**Los Angeles County
Metropolitan Transportation Authority
Office of the Inspector General**

**Review of the Expo/Blue Line
Junction**

Case No. 2011-0040

December 18, 2012

Figure 3. Comparison of L/V Ratio on the Lead Right Wheel through a Standard Frog (Green) and Expo Frog (Red)

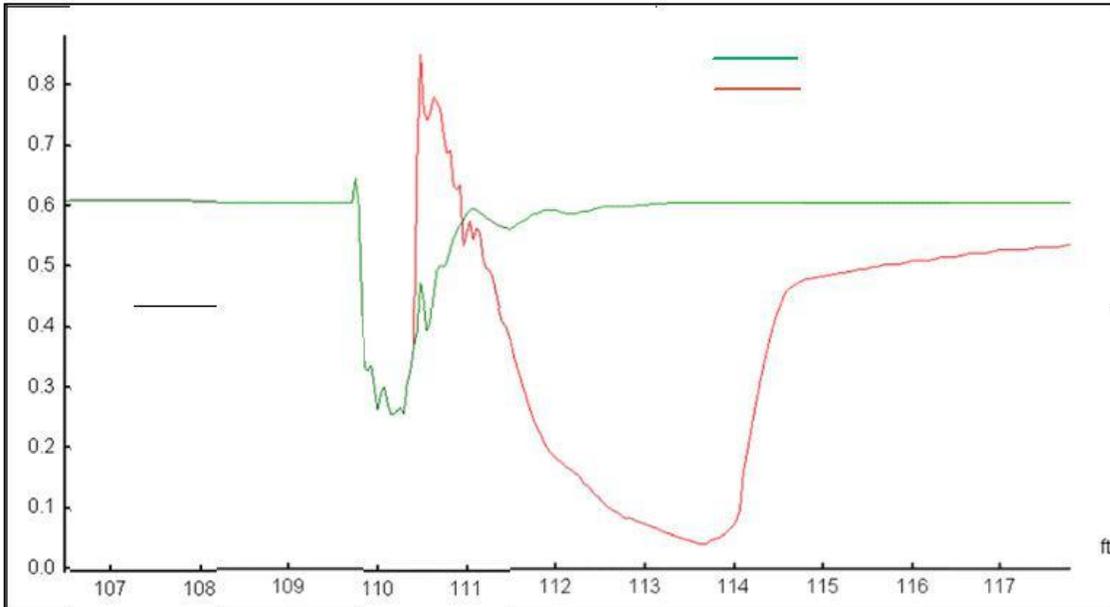
As can be seen from this Figure 3, the Expo frog movement showed an L/V ratio of 0.8, as opposed to the standard movement of 0.6. While 0.8 is sometimes regarded as the “minimum” L/V threshold, ZETA-TECH performed a more detailed analysis of the L/V ratio threshold as a function of the actual wheel flange angle and coefficients of friction using the Nadal wheel climb analysis methodology. The results of the analysis showed that for the new wheel flange angle of 75 degrees (the same as was used by ENSCO in the modeling run) and for a range of coefficient of friction of 0.3 to 0.5, the actual L/V derailment threshold is 1.13, well above the model calculated L/V ratio through the Expo frog (of 0.8). This indicates that there is no risk of wheel climb, since the L/V ratio was less than the Nadal calculated derailment threshold.

Figure 4: Junction Diamond. RED arrows indicate direction of normal travel.

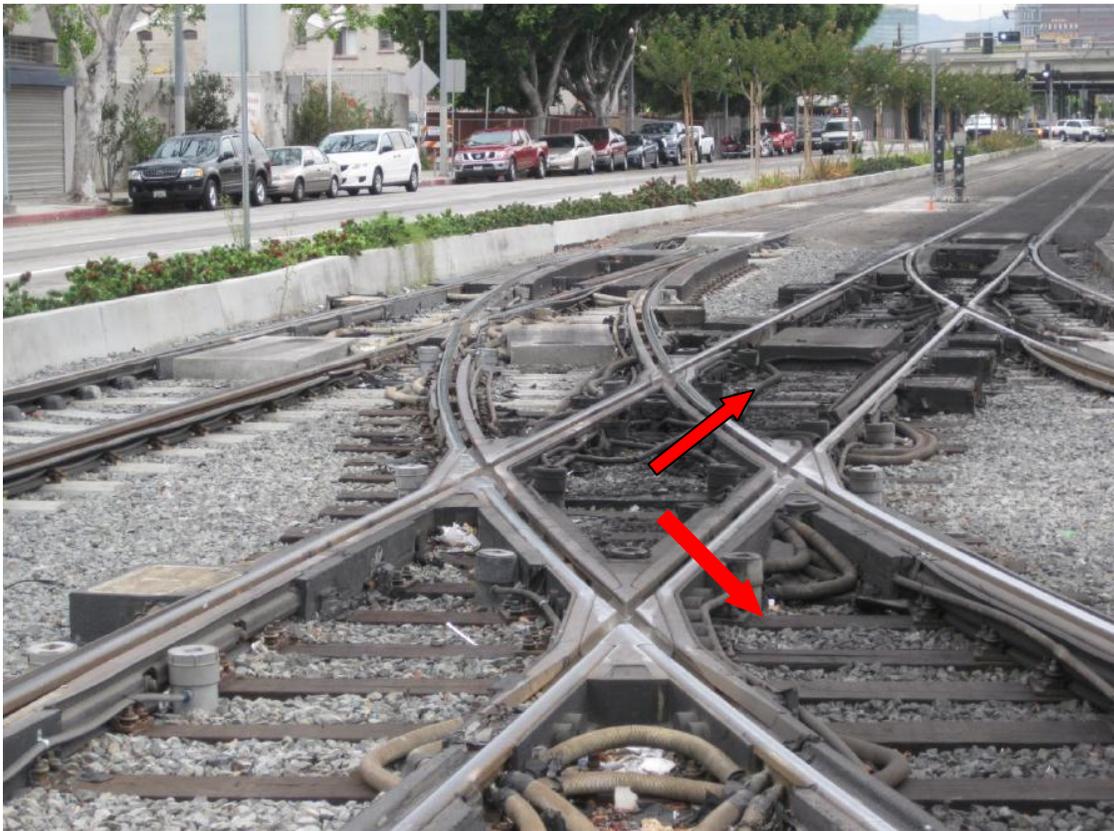
Upon arrival at the Junction Diamond, several trains were observed travelling through the diamond on Track Blue #2 (small radius direction) as well as EXPO #3 (large radius direction). See Figure 4.

Figure 5: Straight move view of the Junction Diamond Looking North

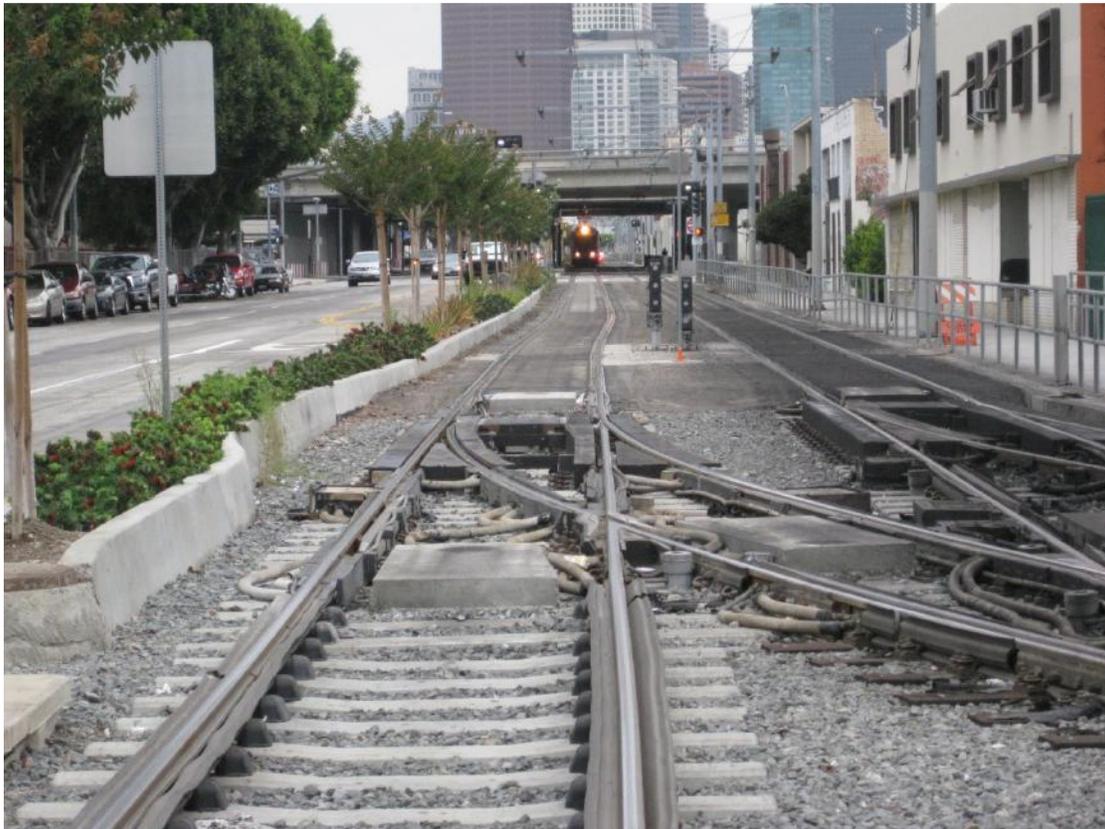
The junction diamond is located between the Grand Station on one side (Figure 5) and Washington Blvd. and Flower Street on the opposite side (Figure 6).

The diamond junction is built on wood tie and ballast track where-as all other track and turnouts are built on concrete ties or embedded track (Figures 5 and 6).

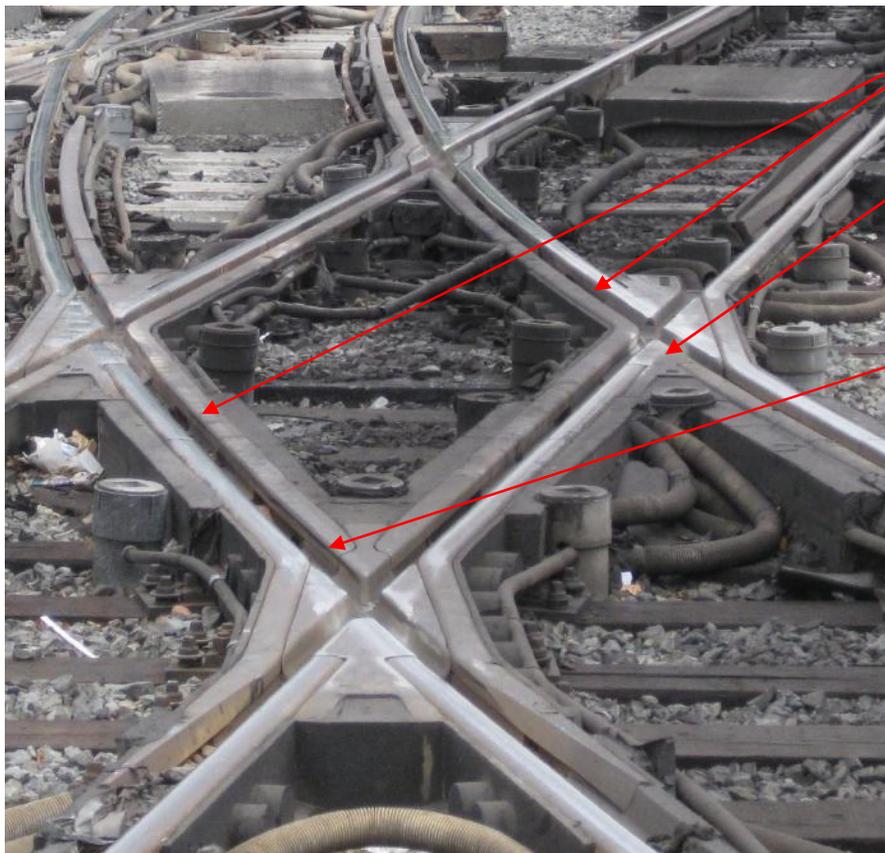
- c) There has been a concern expressed about the ability to transition from the R190 frog at 57 inch gauge¹ to the newly gauged diamond at 56 ½ inch. Should the frog be regauged as well to 56 ½ inches and if not, is there a problem having this transition over such a short distance?

¹ NOTE: The actual gauge, at the ½ inch point of frog for the diverging route was measured at 57 ½".

It would be better if the frog diverging route was reset to standard gauge so that there would be no transition and the frog wing rail would not be subjected to the observed high wear (as noted in Figure 7). However, if, due to time and cost restraints, this procedure is not a realistic option, this lack of transition does not represent a serious problem so long as the "line" rail remains uniform throughout this transition zone. The change in gauge must be facilitated by moving the "grade" rail (inside rail) closer to the line rail by ½ inch and NOT moving the "line" rail from its current position. This transition should take place over a distance not less than the longest axle to axle spacing of any vehicle using this route. In this case, 82.7 inches.

Figure 12A: Replacement Junction Configuration

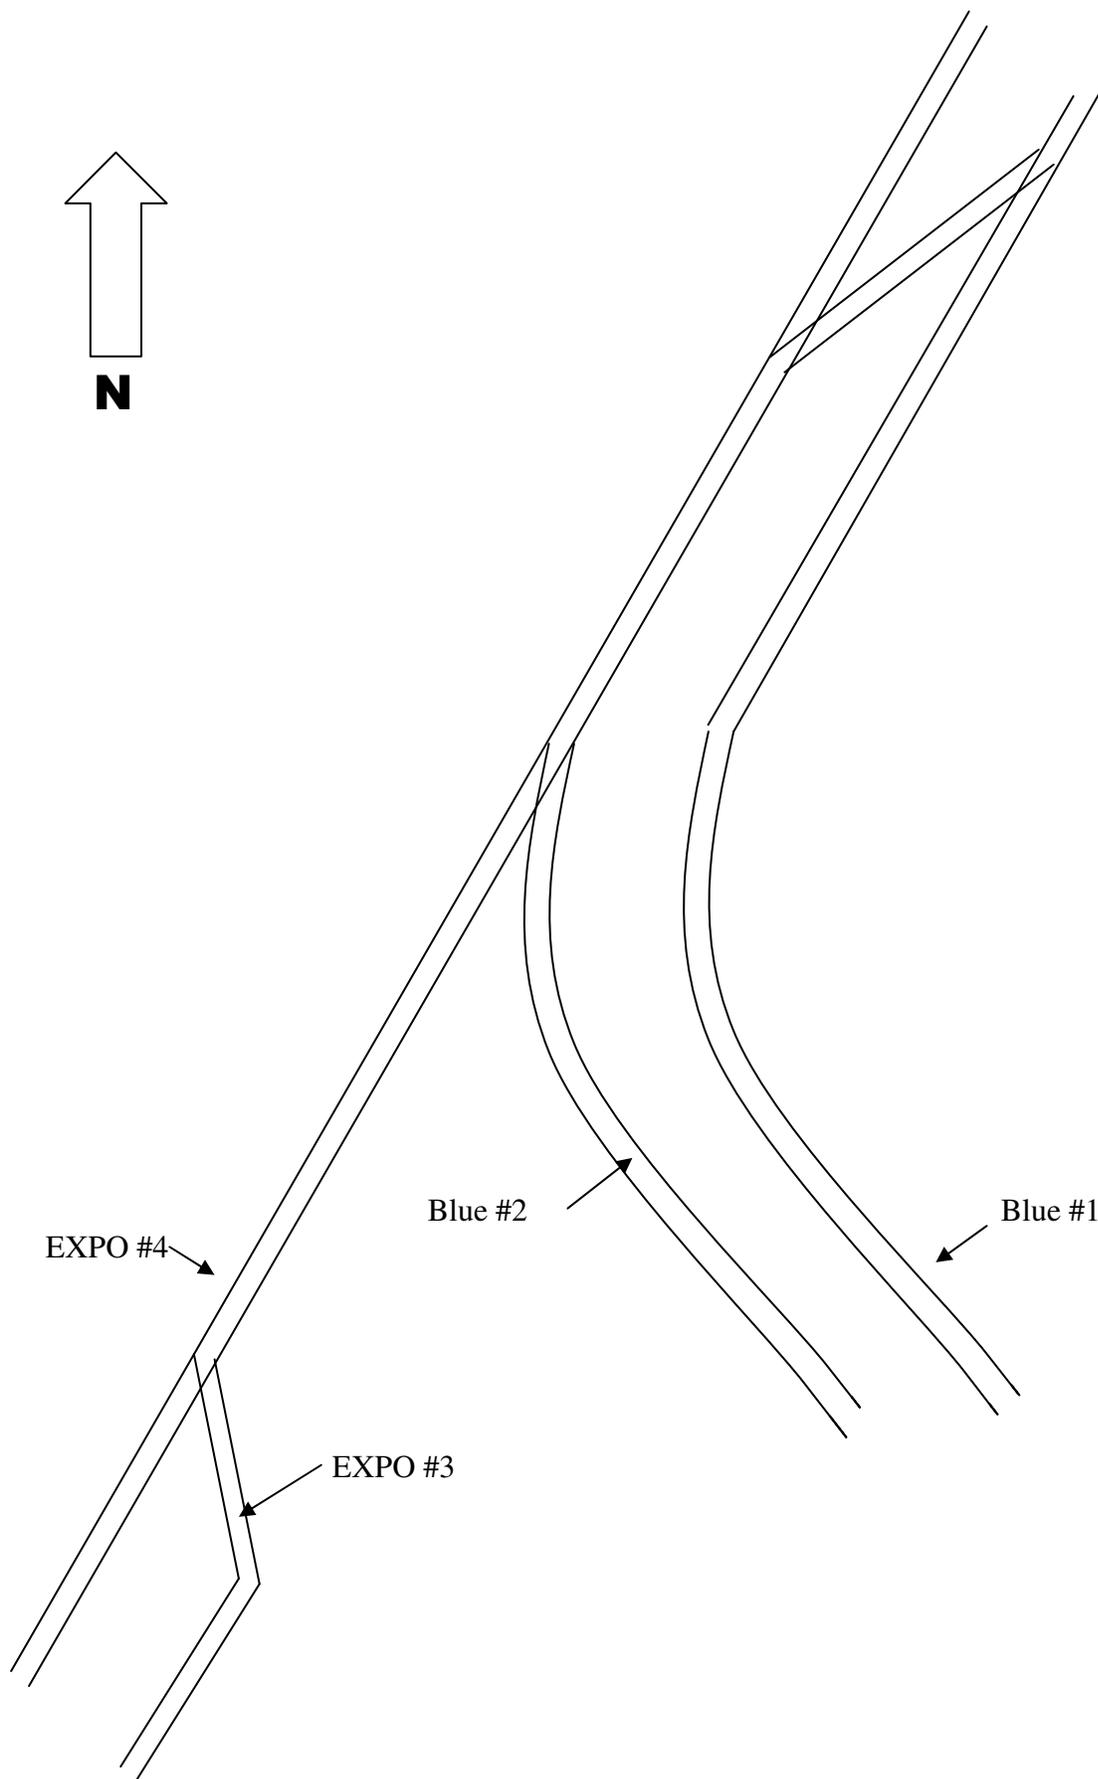
The diamond junction was originally installed to provide the greatest level of operating flexibility. However, due to space limitations, the diamond had to be designed with a 150 foot radius curve which limits train speed and may present maintenance issues. The full diamond junction can be replaced with a crossover. This would remove the existing diamond configuration and its associated maintenance problems, and increase speed of operation through this junction area.

This is accomplished through the new –proposed- junction configuration shown in Figure 12A. In this configuration, EXPO#3 is joined to EXPO#4 south of Flower Street, then single tracked across the roadway and through the 4.5 turnout, with a cross-over installed to bring EXPO#3 back over to Blue#1. The diamond could then be removed and Blue#2 would be connected directly to the number 4.5 turnout (see Figure 12A.).

If this level of operation is acceptable, then it is strongly recommended that the diamond be eliminated and replaced with this new, higher speed, operating configuration. In addition to the higher operating speeds, this configuration would greatly reduce the level of maintenance at this junction. However; it is possible that this layout may impact and limit future operating flexibility and headways and therefore must be reviewed and approved by Operations prior to any modifications being made.

Figures 12B: Before Traffic Flow

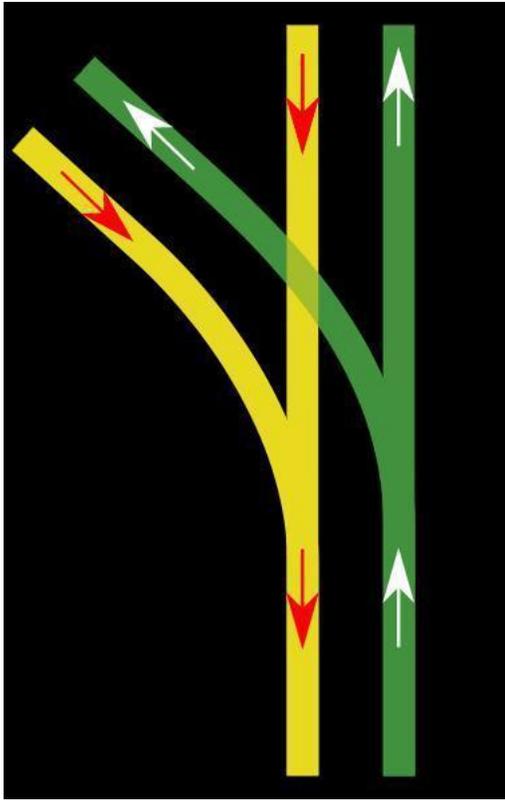
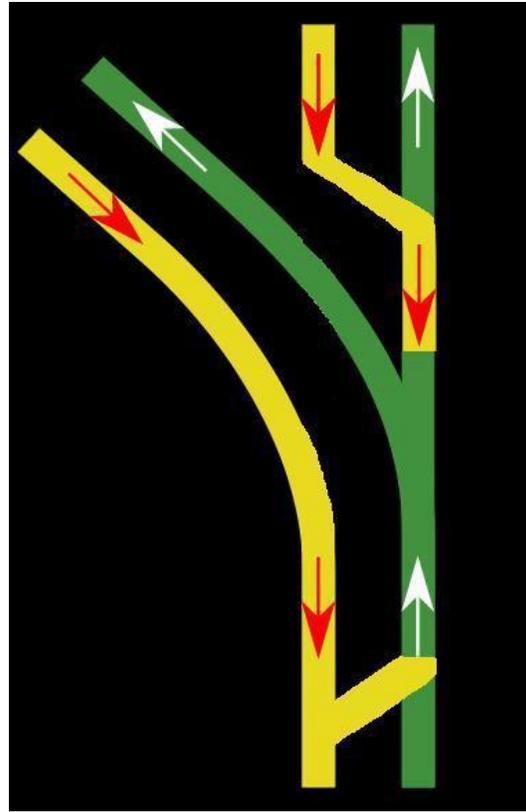
Figures 12B and 12C show the proposed traffic flows.
